Enclosed herewith is "Notice of Revision and Addendum in Contract Documents," Addendum 11, consisting of two (2) pages and other attachments as referenced in the addendum. This addendum is dated April 14, 2026, and pertains to Contract 21-092-3P, "Battery E Activated Sludge Facility, O'Brien Water Reclamation Plant."

**ADDENDUM 11**

**CONTRACT 21-092-3P  
BATTERY E ACTIVATED SLUDGE FACILITY  
O'BRIEN WATER RECLAMATION PLANT**

- NOTES**
- CURB AND GUTTER**
1. PROVIDE EXPANSION JOINTS AT ALL POINTS OF CURVATURE, POINT OF TANGENT, FIVE FEET ON EITHER SIDE OF ANY FRAMES, AND AT 50 FEET MAX. INTERVALS.

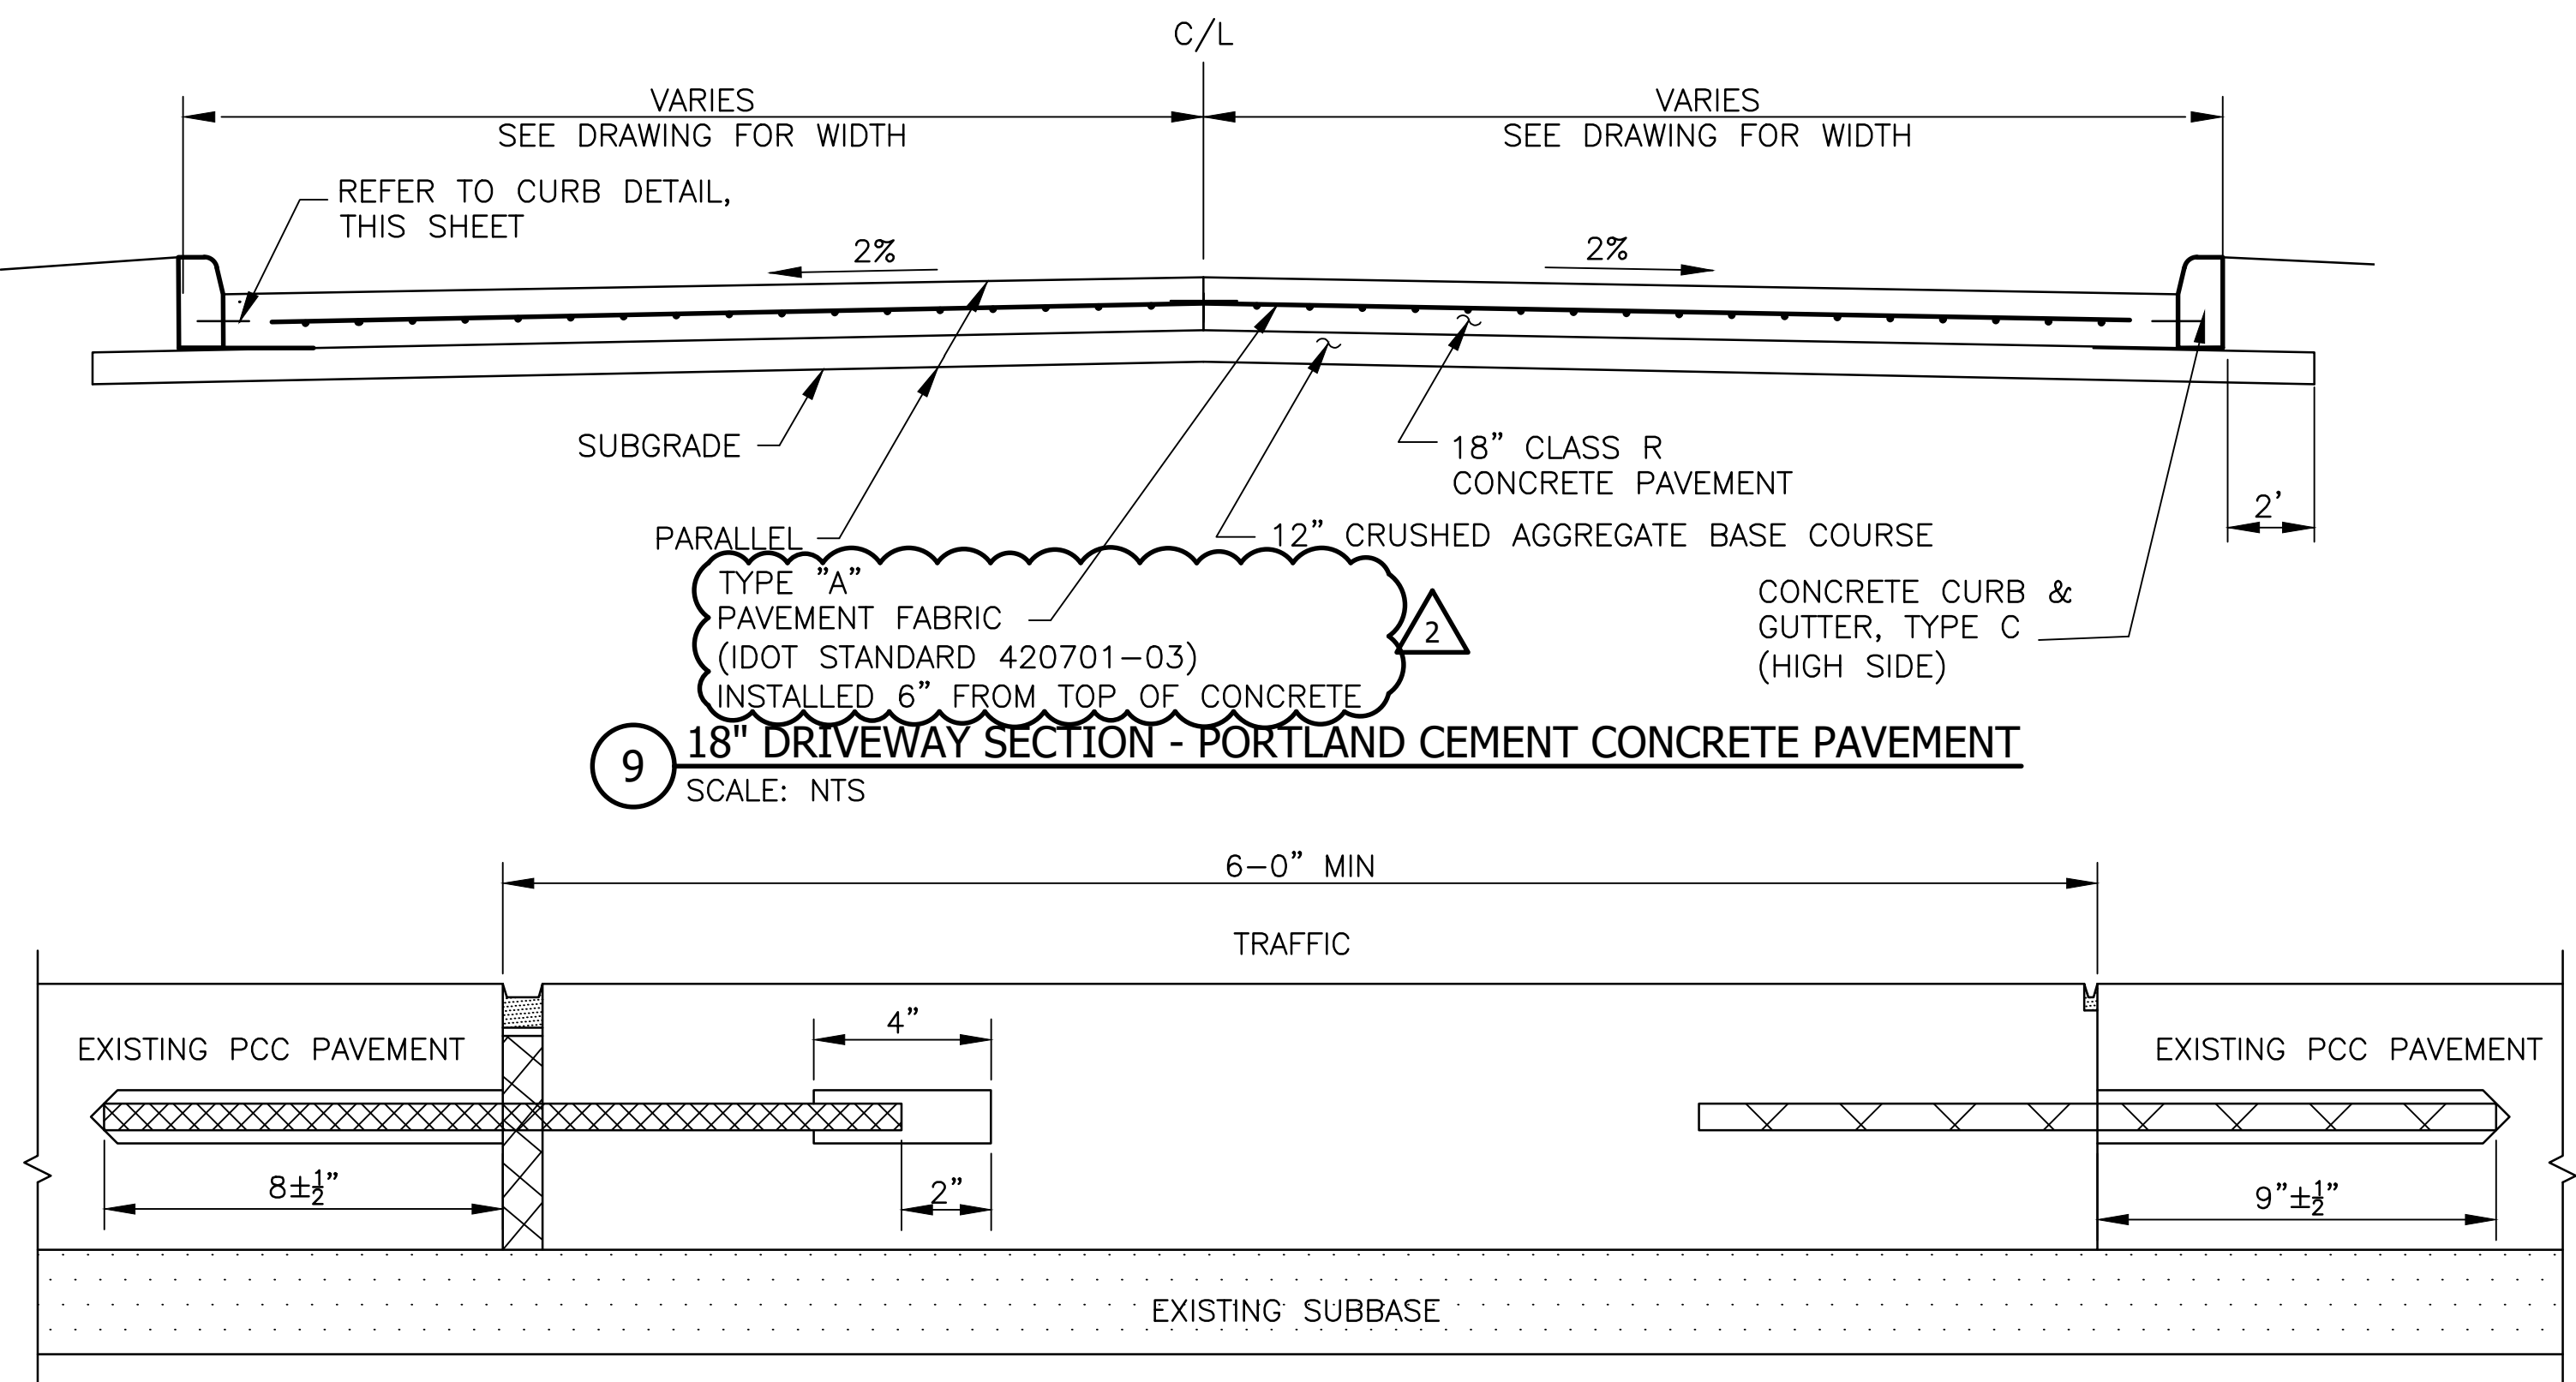
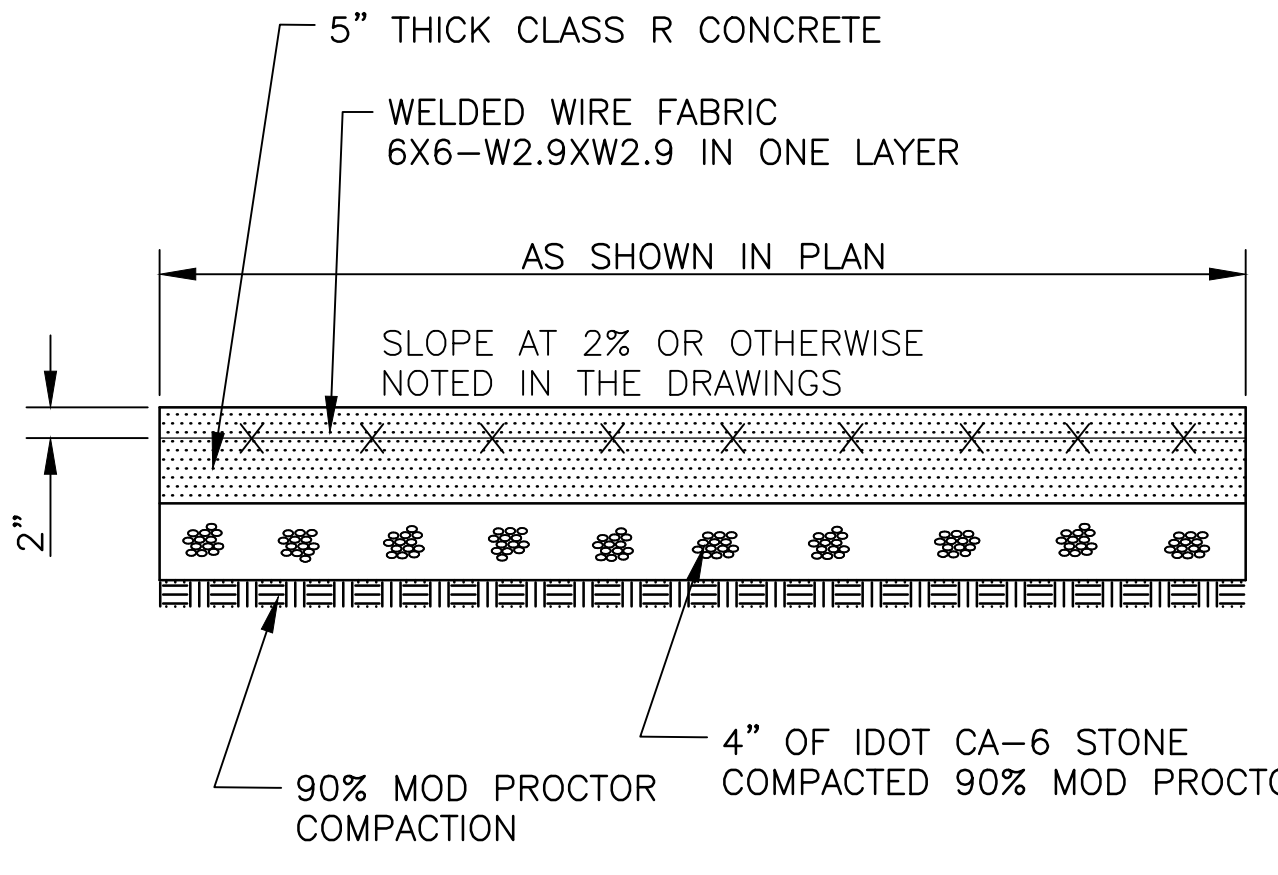
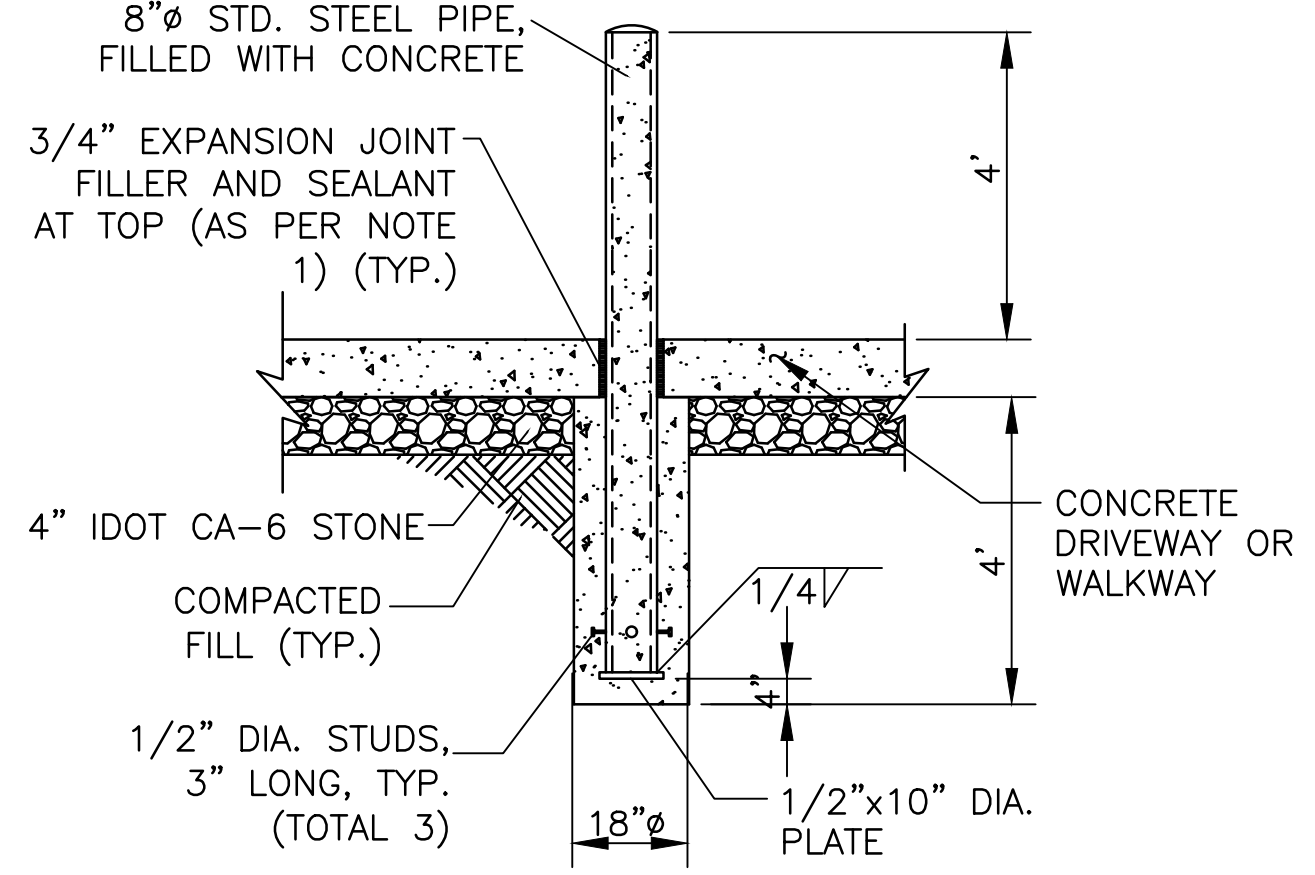
| <u>PAGE NO.</u> | <u>SHEET NO.</u> | <u>REV#</u> | <u>TITLE OF SHEET</u>                      |
|-----------------|------------------|-------------|--|
| 32              | C-016            | 2           | STANDARD DETAILS - 5                       |

| Rev. | Description     | Appr. | Date    |
|------|-----------------|-------|---------|
| 2    | ADDENDUM NO. 11 | HC    | 4/13/26 |

**CONTRACT 21-092-3P**  
OBRIEN WATER RECLAMATION PLANT  
BATTERY E ACTIVATED SLUDGE FACILITY  
OPERATING GALLERY  
ELEVATIONS

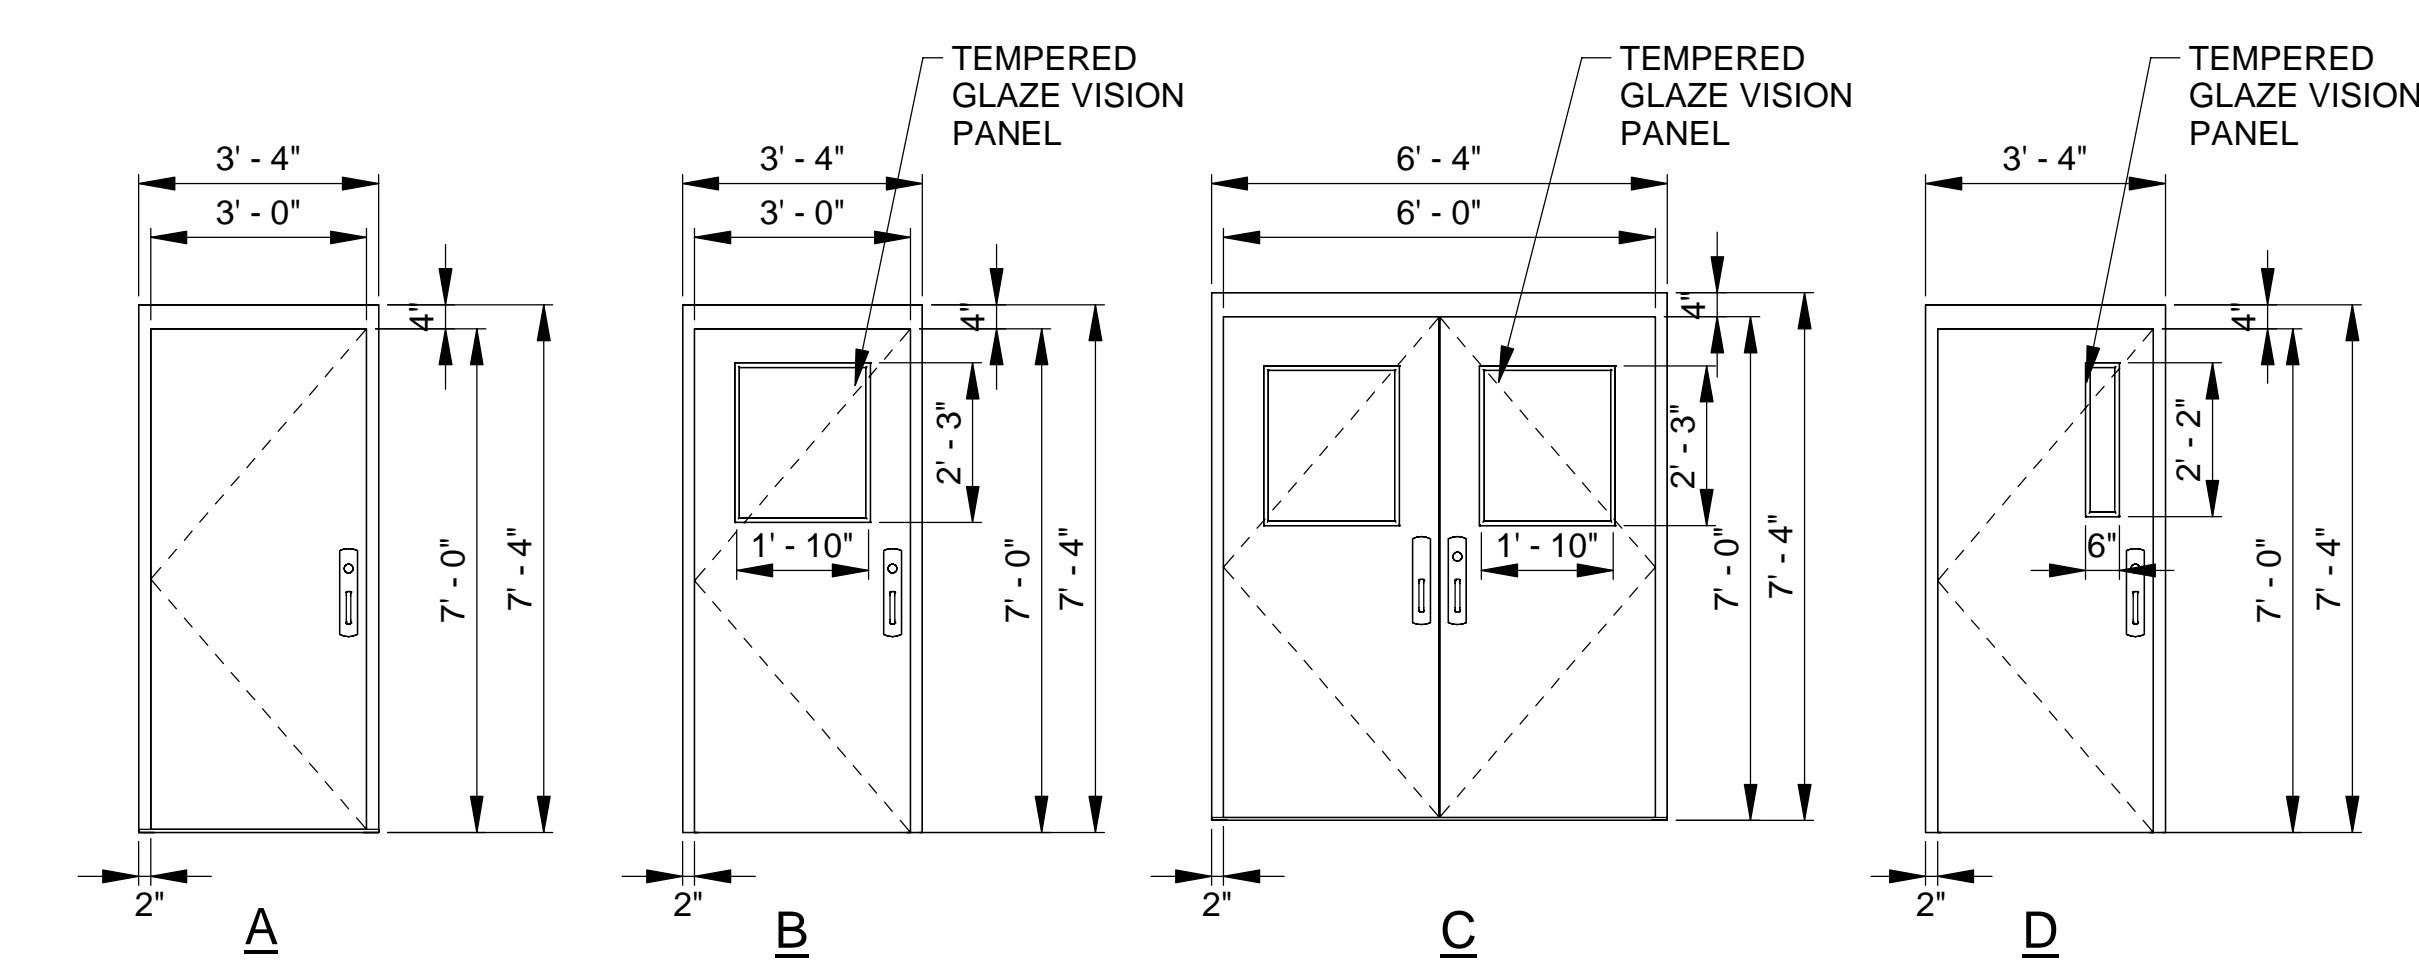
| <u>PAGE NO.</u> | <u>SHEET NO.</u> | <u>REV#</u> | <u>TITLE OF SHEET</u>                      |
|-----------------|------------------|-------------|--|
| 227             | A-403            | 2           | ELEVATIONS                                 |

| Rev. | Description     | Date     |
|------|-----------------|----------|
| 2    | ADDENDUM NO. 11 | 04/13/26 |
